DATE: February 9, 2017
TO: Kerman Morris
FROM: Joshua Switzky, Planning Department
RE: PPA Case No. 2015-015133PPA for 301 Grove Street

Preliminary Project Assessment

Date: February 9, 2017
Case No.: **2015-015133PPA**
Project Address: 301 Grove Street
Block/Lot: 0809/001
Zoning: Moderate Scale Neighborhood Commercial Transit District (NCT-3)
50-X Height and Bulk District
Area Plan: Market and Octavia Area Plan
Project Sponsor: Kerman Morris
(415) 749-0302
Staff Contact: Anne Brask – (415) 575-9078
Anne.Brask@sfgov.org

Title: 301 Grove Street
Comments: Measured at a height of 69 feet.
Printed: 8 December, 2016

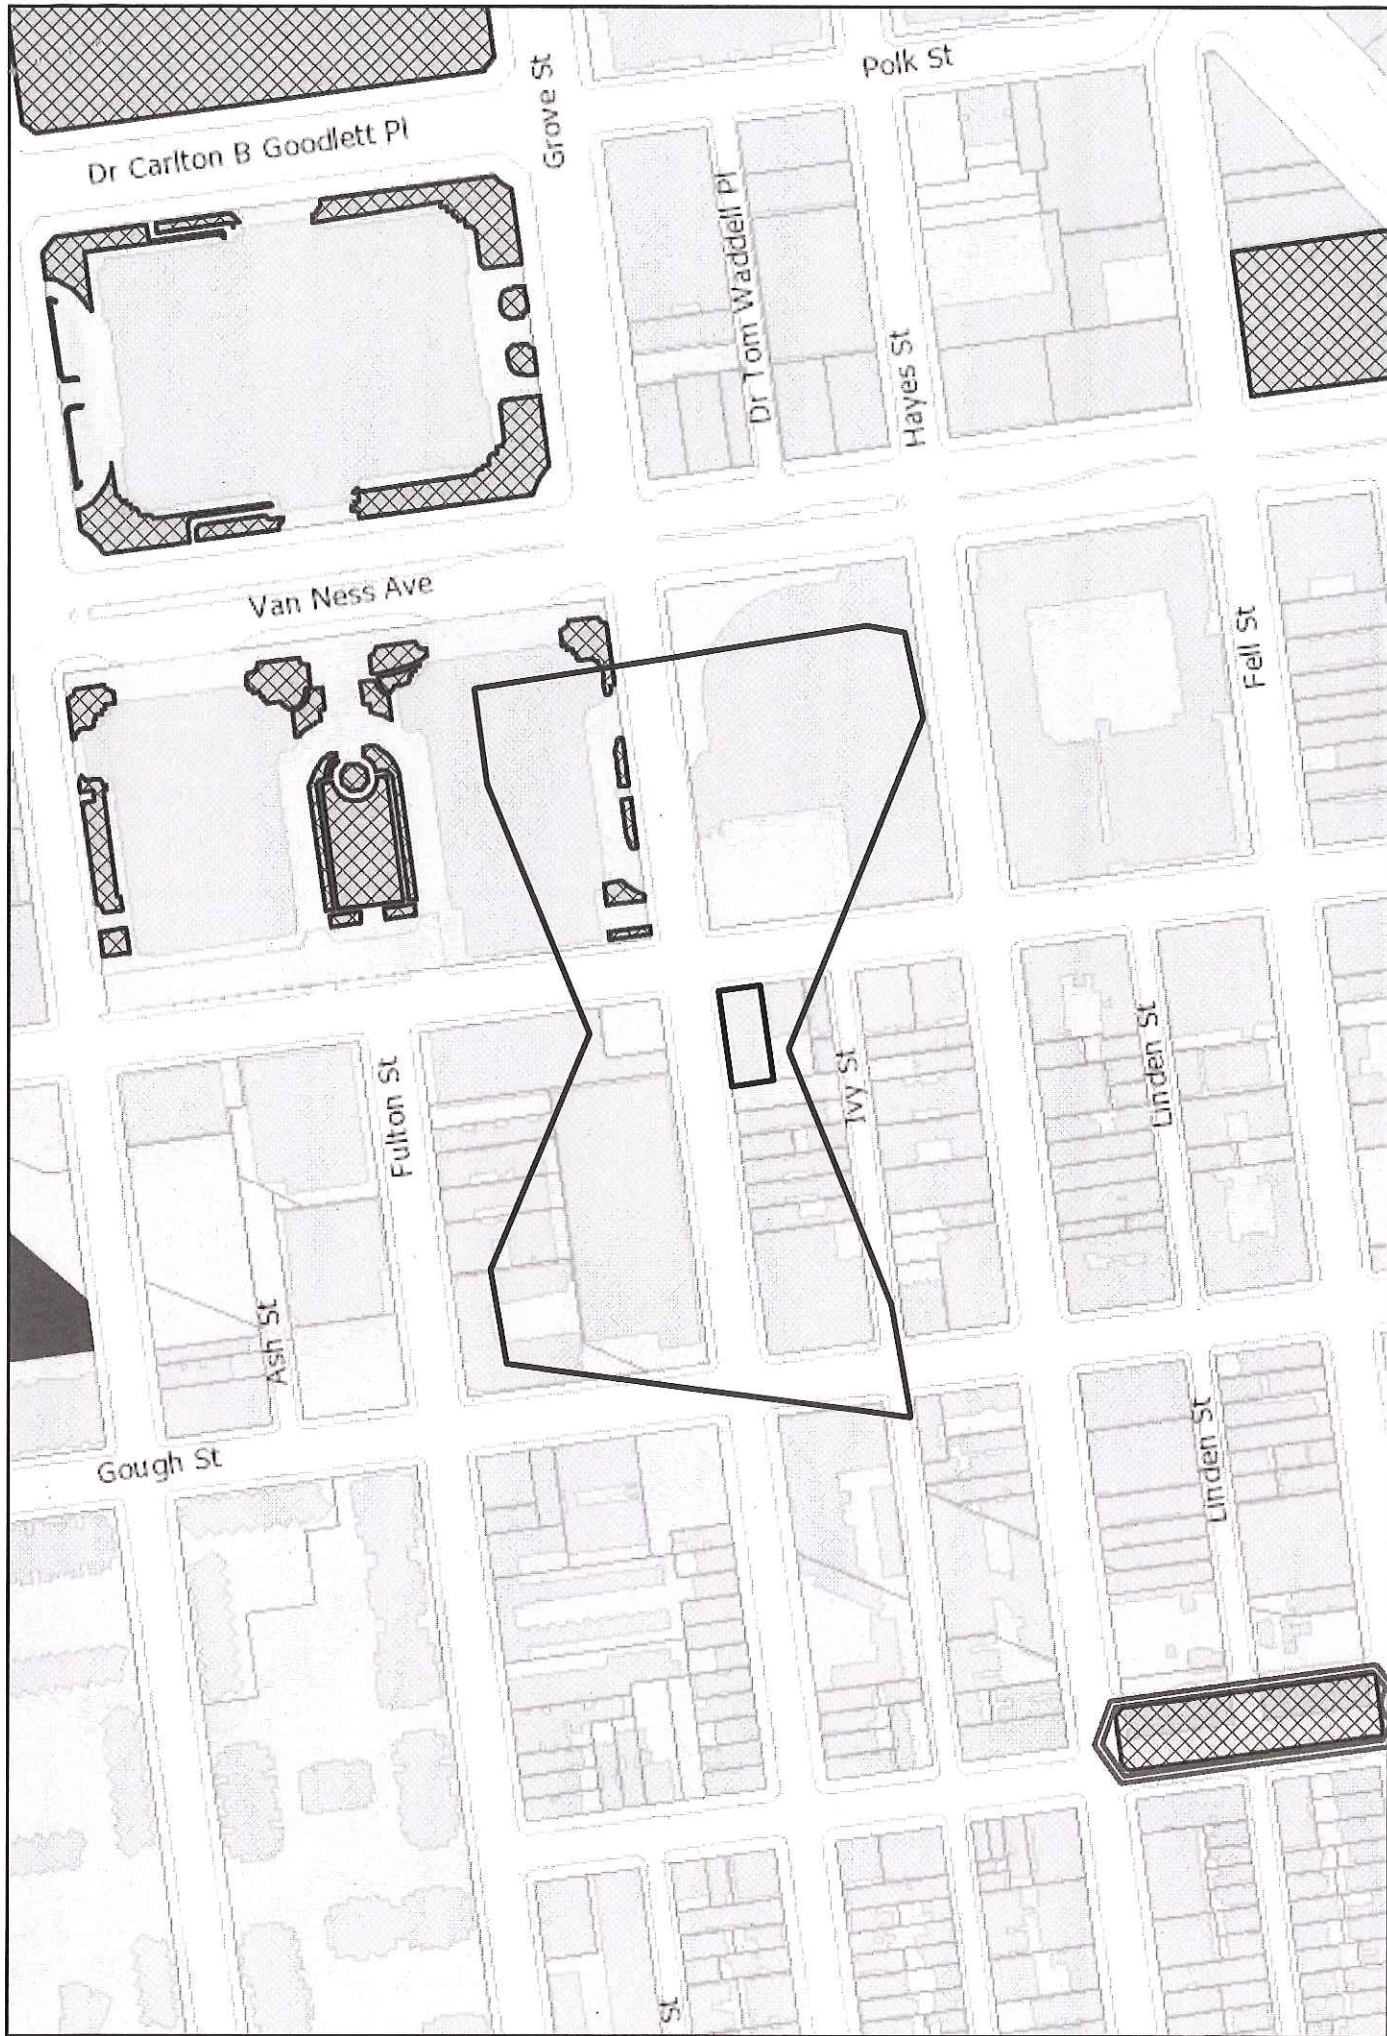
8. **Shadow.** The proposed project would result in construction of a building greater than 40 feet in height. A preliminary shadow fan analysis prepared by Planning Department staff indicates that the proposed project would not cast shadows on recreational resources subject to Planning Code Section 295 (which applies to properties under the jurisdiction of the Recreation and Parks Department), but could cast shadows on public spaces surrounding the War Memorial Opera House, which are not subject to Section 295¹. The *Market and Octavia FEIR* stated that development along Grove Street across from the War Memorial Open Space, including the project site, would potentially cast shadows on the open space year-round, in the mid-late afternoon hours. The project sponsor is therefore required to hire a qualified consultant to prepare a detailed shadow study. The consultant must submit a Shadow Study Application, which can be found on the Planning Department's website (<http://www.sf-planning.org/Modules/ShowDocument.aspx?documentid=539>). A separate fee is required. The consultant must also prepare a proposed scope of work for review and approval by Environmental Planning staff prior to preparing the analysis. Mitigation Measure 5.5.A2, Parks and Open Space not Subject to Section 295, will likely be required.

8. **Shadow Analysis.** Section 295 requires that a shadow analysis must be performed to determine whether the project has the potential to cast shadow on properties under the jurisdiction of the San Francisco Recreation and Park Commission. Department staff has prepared a shadow fan that indicates the project may cast new shadow on the property containing the San Francisco War Memorial and Opera House (property under the jurisdiction of the San Francisco Recreation and Park Commission). Therefore, a detailed shadow analysis would need to be prepared to determine if the project would create new shadow in that results in an adverse impact to the San Francisco War Memorial and Opera House, pursuant to Section 295. If this detailed shadow analysis finds that the project would cast shadow on the San Francisco War Memorial and Opera House, the sponsor should explore sculpting of portions of the project to avoid casting new shadows on the property.
